APPROVED MINUTES

July 17, 2014 Standards Committee Meeting (Changes to the Final Draft Minutes shown highlighted teal.)

RE: First Draft Minutes for the July 17, 2014 Standards Committee Meeting

REVISION TO RECURRING SPECIAL PROVISIONS AND RECURRING PLAN DETAILS
 805-T-173d WIRELESS VEHICLE DETECTORS (WITH MARKUPS)

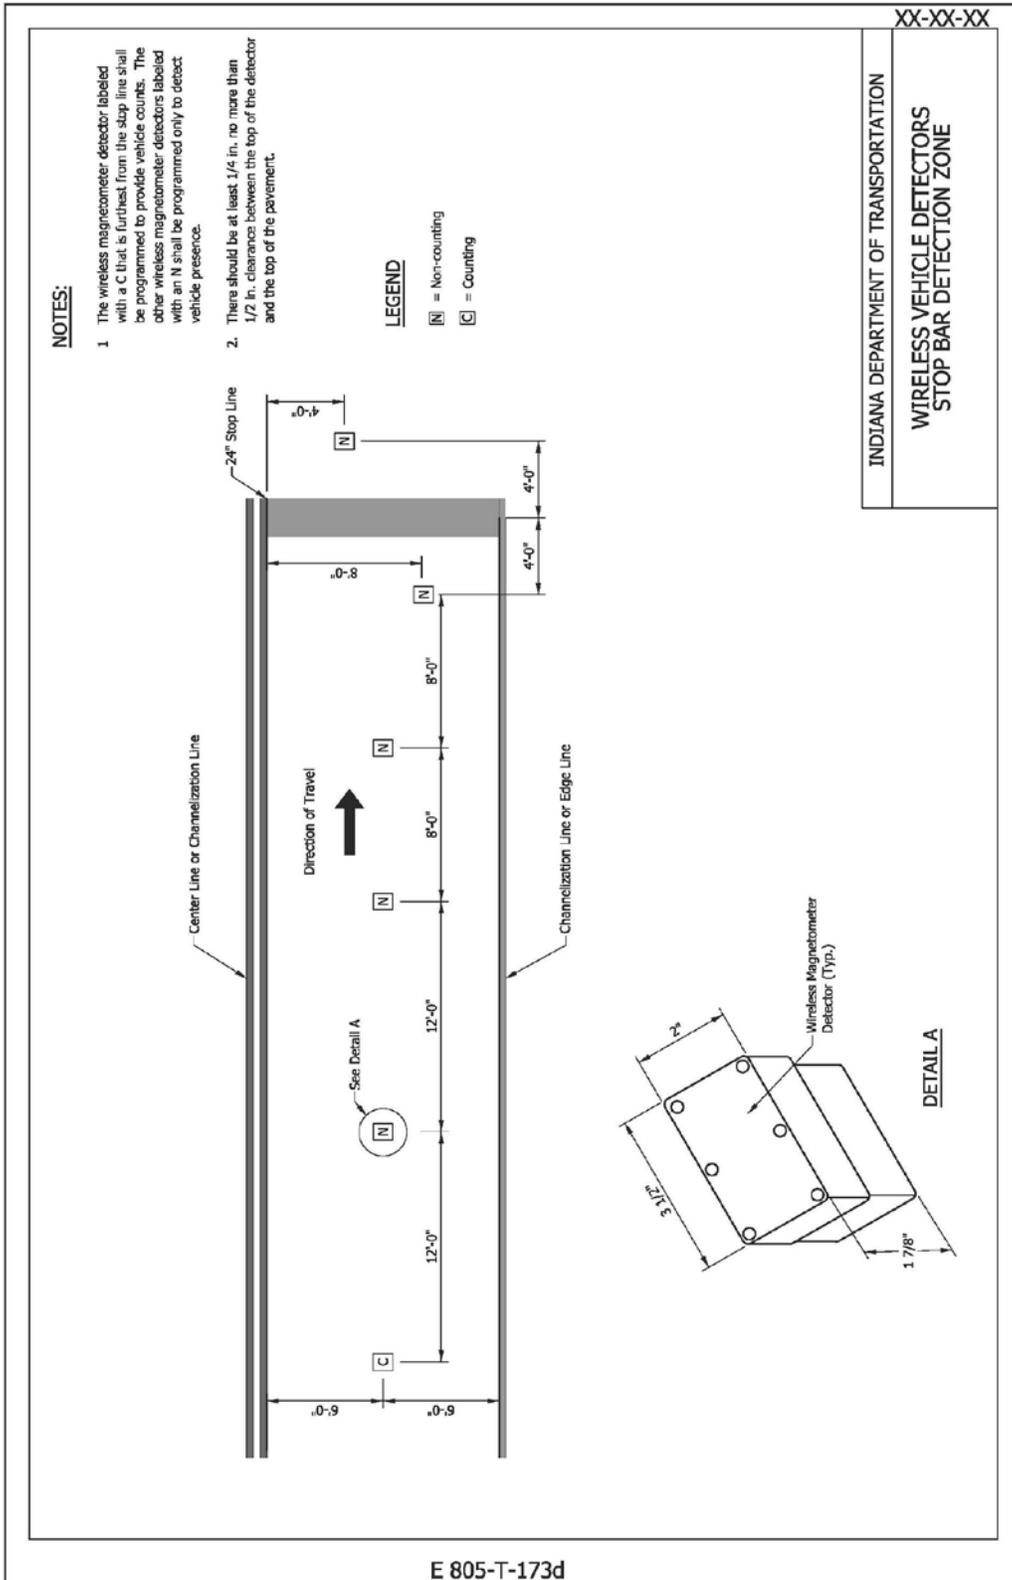
1. The wireless magnetometer labeled with a C that is furthest from the stop line shall be programmed to provide vehicle counts. The other wireless magnetometer detectors labeled with an N shall be programmed only to detect vehicle presence.

REVISED IDM FIGURE 502-3A TYPICAL WIRELESS VEHICLE-DETECTION SYSTEM
 (DRAFT)

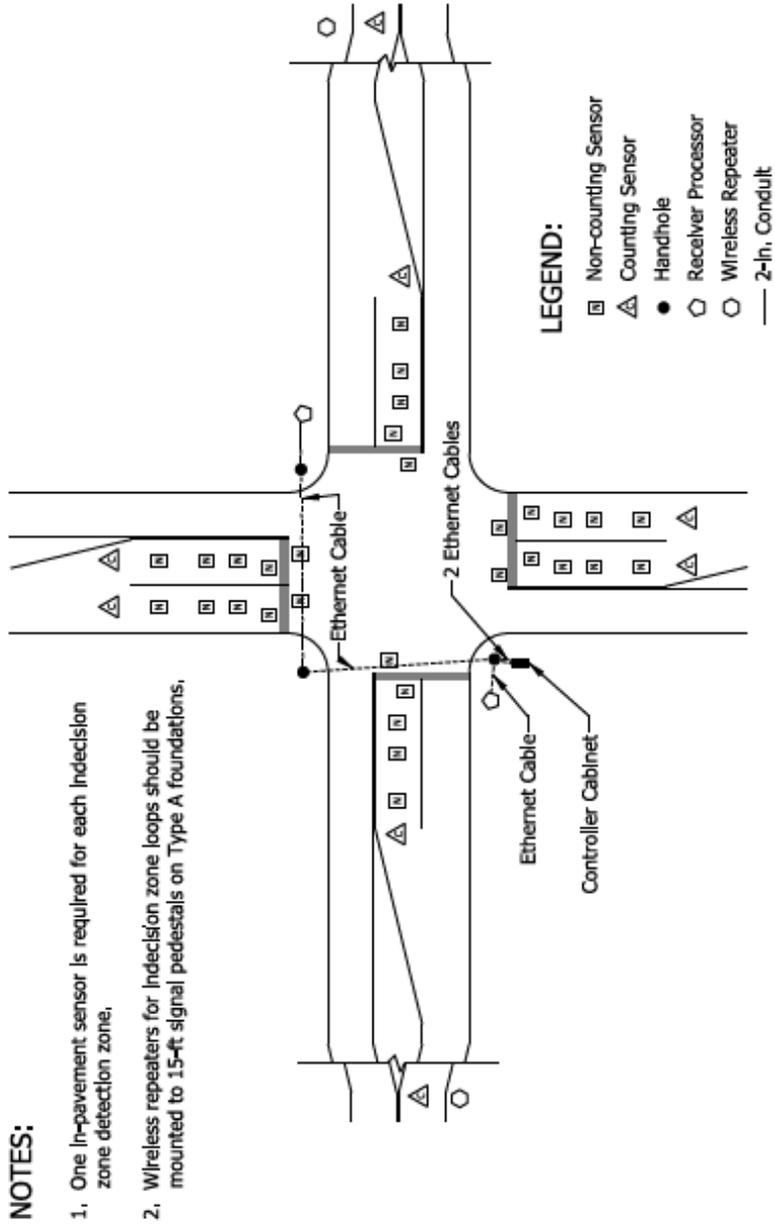
Mr. Bruno offered that the figure in the drawings has been updated to match the proposed revisions.
